May 23, 2008

Additional Information for
Application to Amend Special Use Permit File No. 72/SUP-1
Makakilo Quarry: Grace Pacific Corporation
Tax Map Keys 9-1-16: 4; 9-2-2: 6; and 9-2-3: 74 and 82

**MAKAKILO QUARRY
(Tax Map Key 9-2-3: 82)
CONDITIONAL USE PERMIT NO. 72/CUP-15
ENGINEERING REPORT AMENDMENT**

Figure 5d

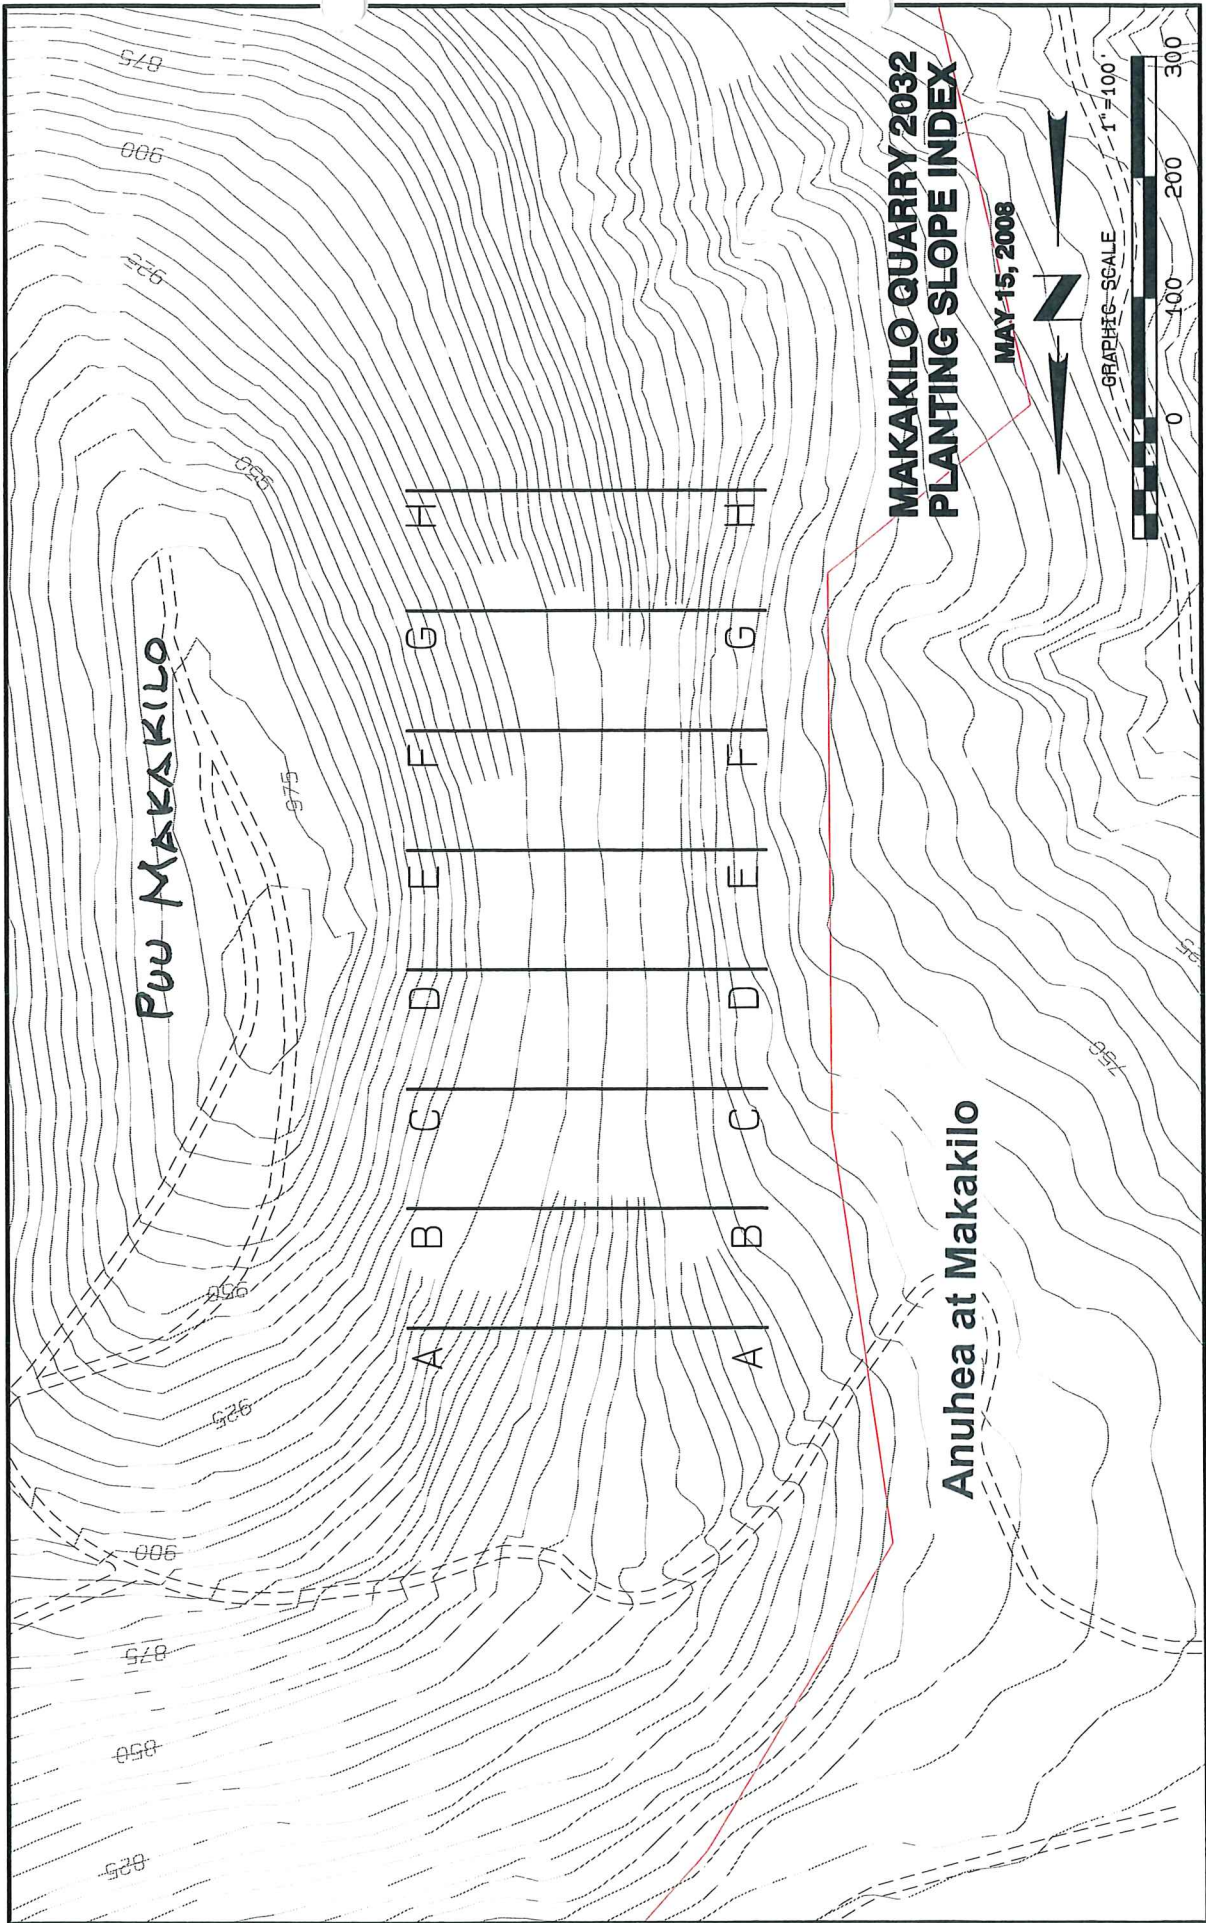
- e) New Figure 5c "Slope Ratio to Percent" table for reference purposes.
- f) New Figures 5d "Planting Slope Index", 5e "Aerial Photo with Planting Slope Index", and 5f "Planting Slope Cross Sections AA through HH" depicting the slopes above the Anuheia Subdivision and the ability of vegetation to establish itself. Note that the image in Figure 5e is also used in Exhibit 2-9 of Appendix E in the Engineering Report Amendment.

Figure 4

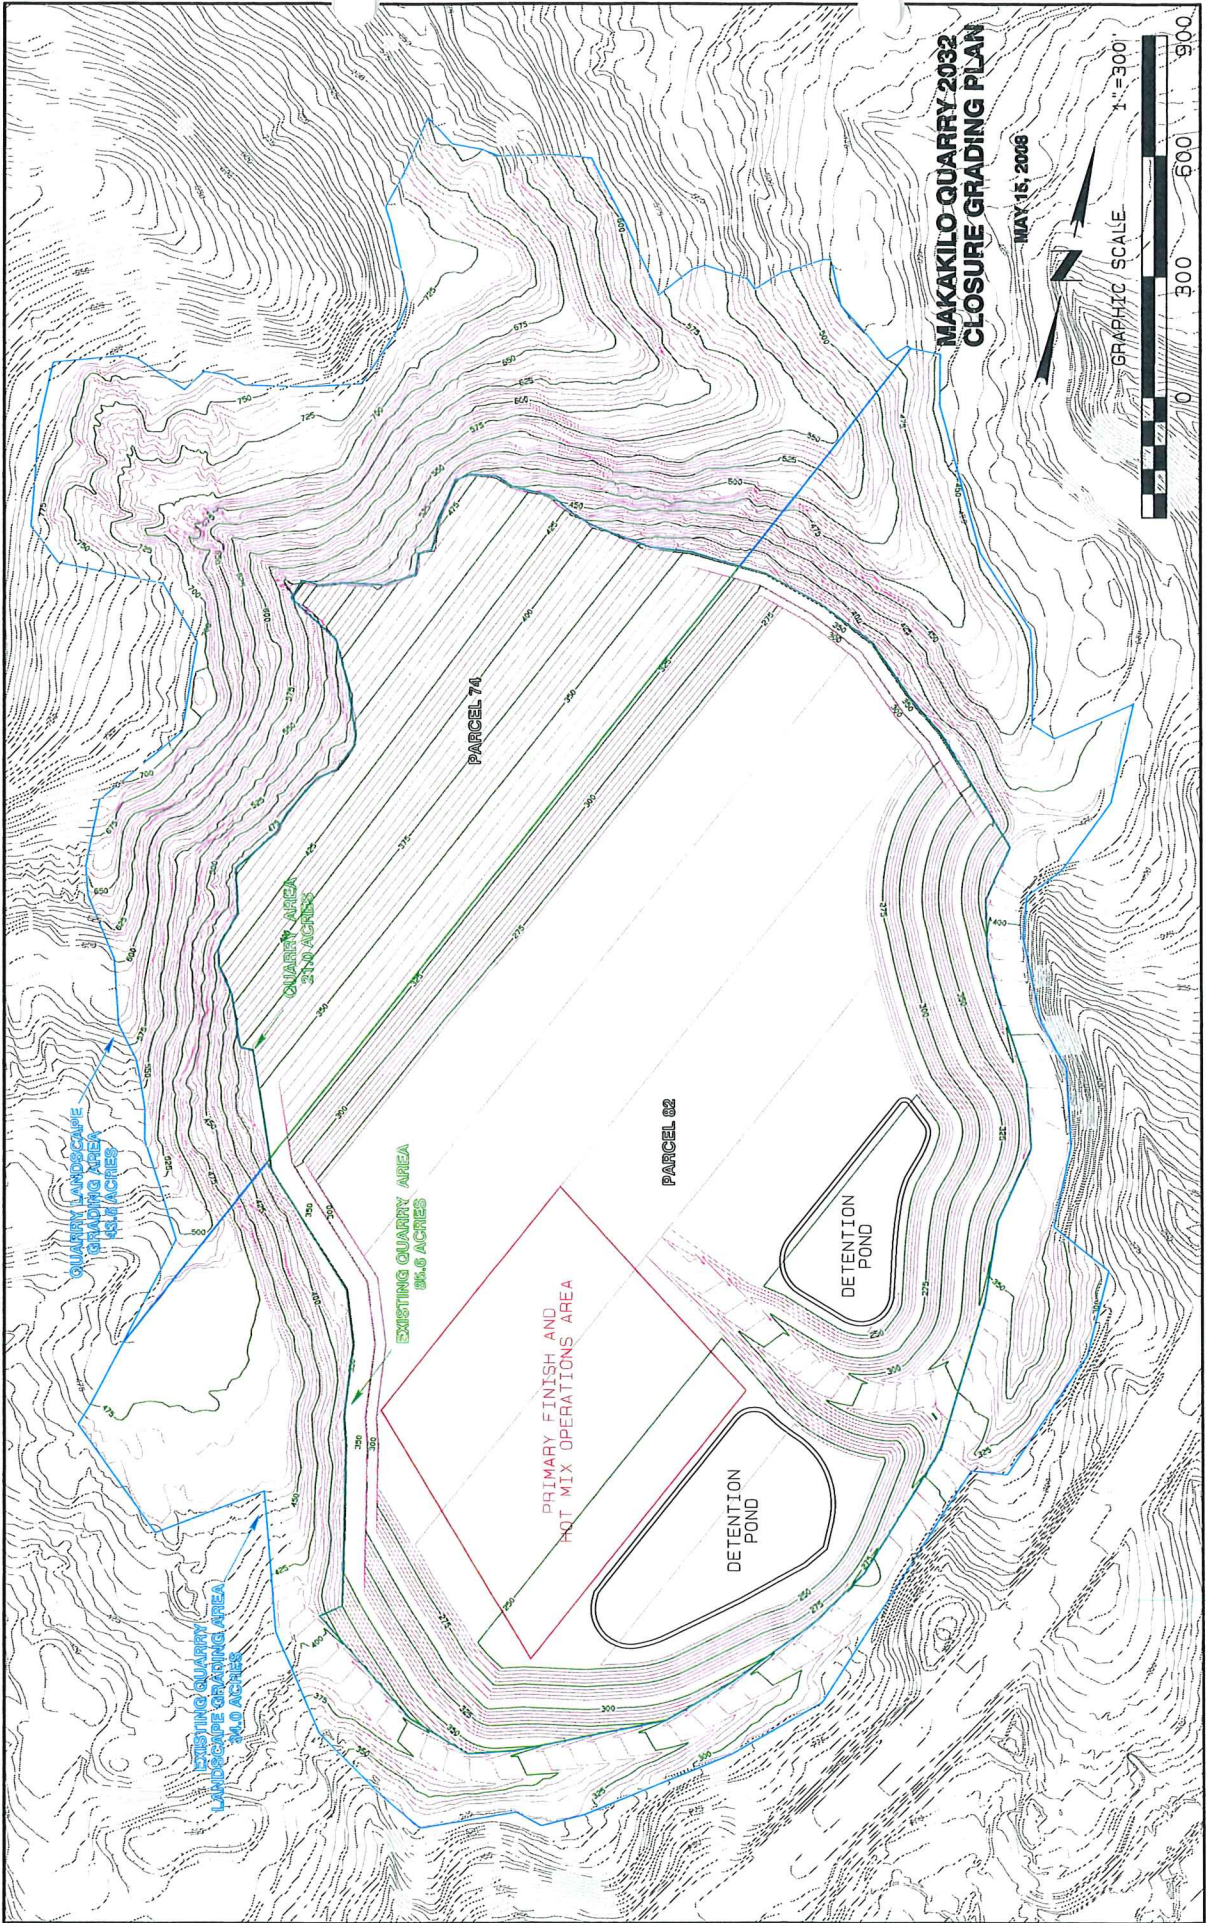
- a) Revised Figure 4 "Overall Site Plan (Closure Grading Plan)" in Exhibit K "Engineering Report Amendment," Appendix B of the SUP Application. Figure 4 is presented in full size (30" x 40") and reduced (8.5" x 11") formats. The area marked as "Primary, Finish and Hot Mix Operations Area" includes Shop and Office use.
 - The acreages for the Proposed Quarry and Proposed Landscape Grading are included in this figure. Please note that the earlier 33-acre area that was shown for the proposed expansion used the toe (edge of the quarry floor) of the face on the side facing Makakilo, and the top of the face on the mauka and Kunia sides.

- The revised Figure 4 uses the toe of the quarry face on all three sides, as outlined in green, to identify the Quarry Area. The blue line delineates the extent of the landscape grading, with the area between the blue and green lines characterized as the Landscape Grading Area. The increase in total acres is due largely to the increased landscape grading. The following table compares the total under the April 2007 and May 2008 quarry and landscaping plans:

Quarry	Landscape Grading	Total
Expansion Area (parcel 74)			
April 2007 application	33.5 acres	14.7 acres	48.2 acres
May 2008 revision	21.0 acres	43.6 acres	64.6 acres
Existing Area (parcel 82)			
April 2007 application	94.0 acres	13.0 acres	107.0 acres
May 2008 revision	85.6 acres	34.0 acres	119.6 acres

Figure 5a

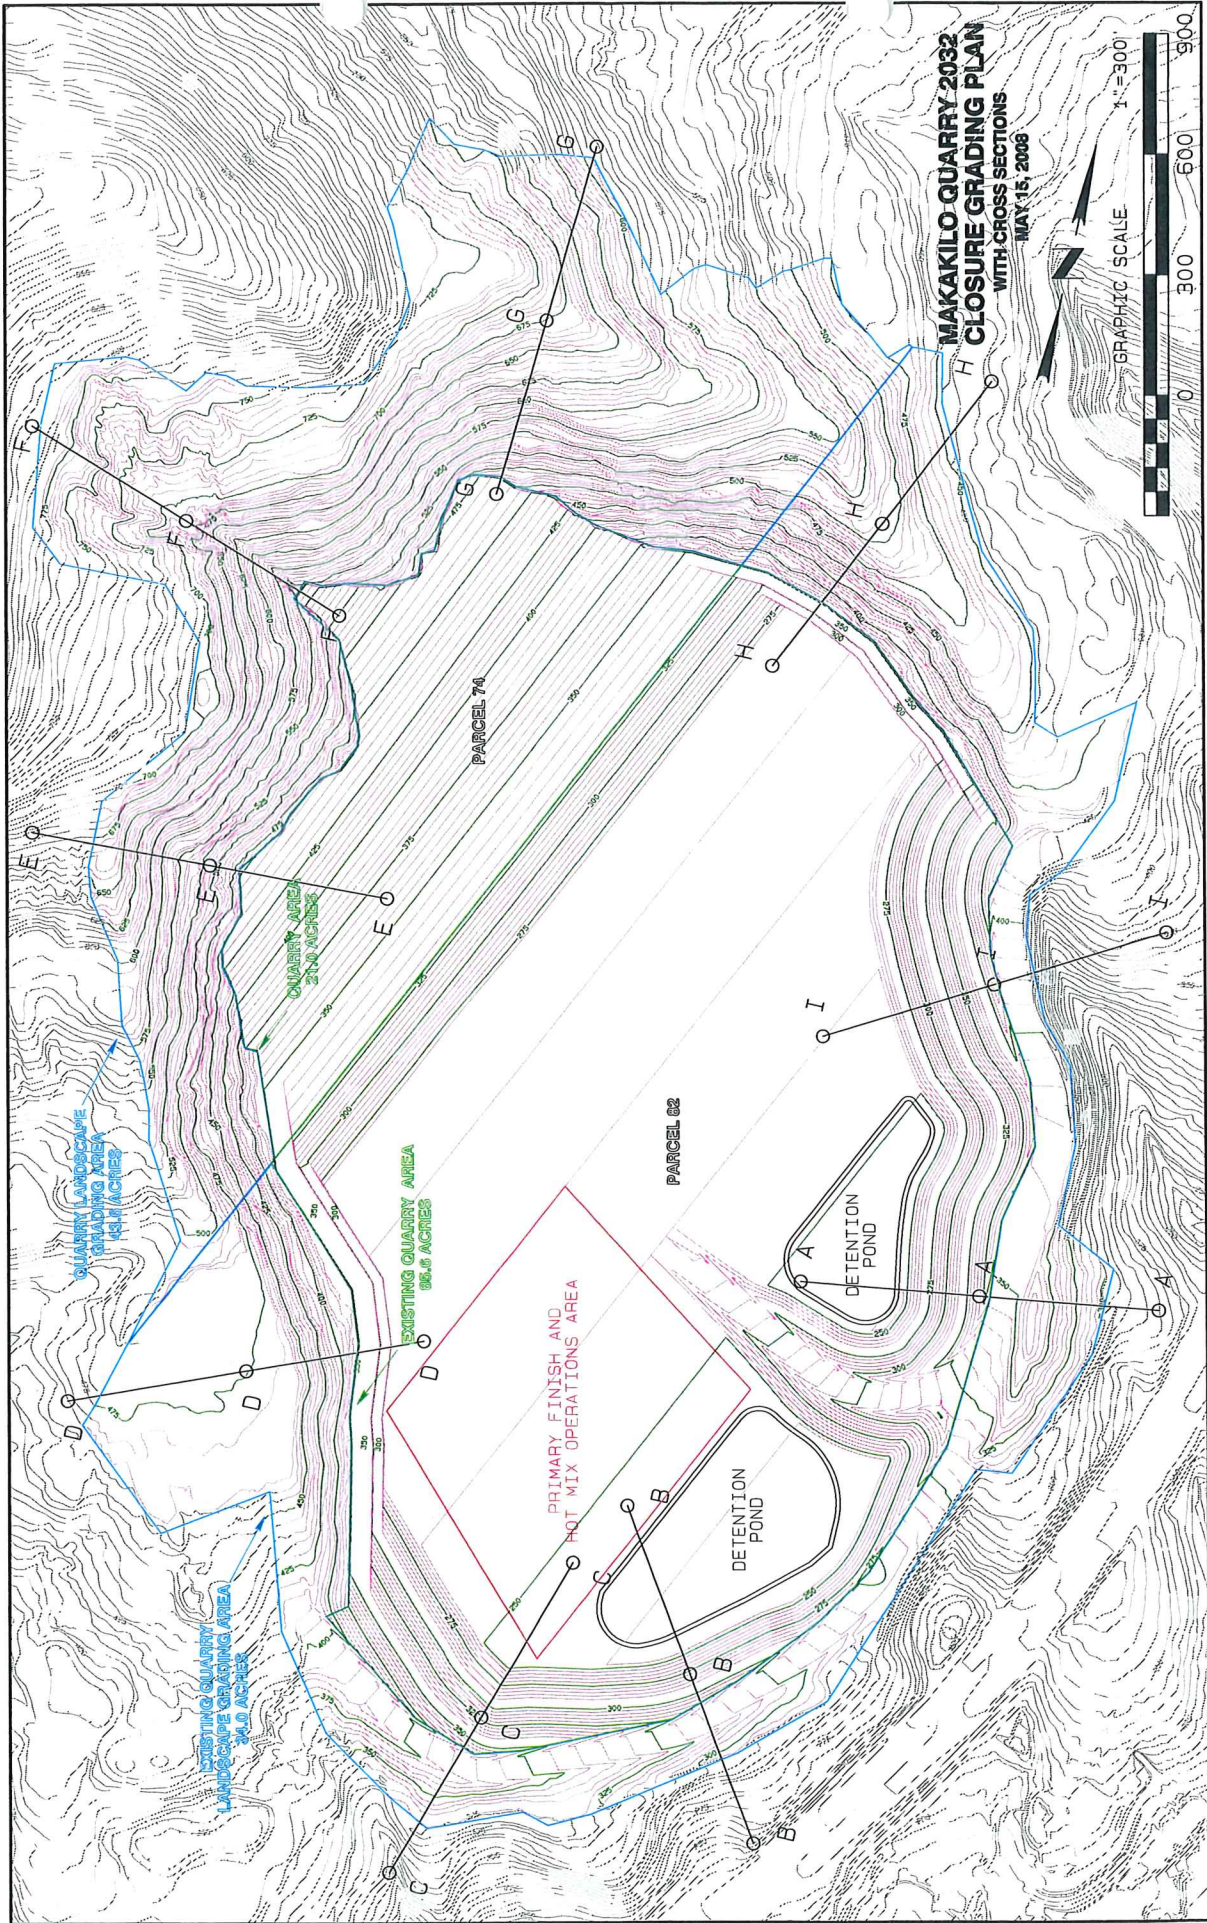
- c) Revised Figure 5a "Closure Grading Plan with Cross Section Index" in Appendix B of Exhibit K "Engineering Report Amendment" of the Application.
- d) Revised Figure 5b1 - Bb9 "Cross Sections AA through II", accompanying revised Figure 5a.
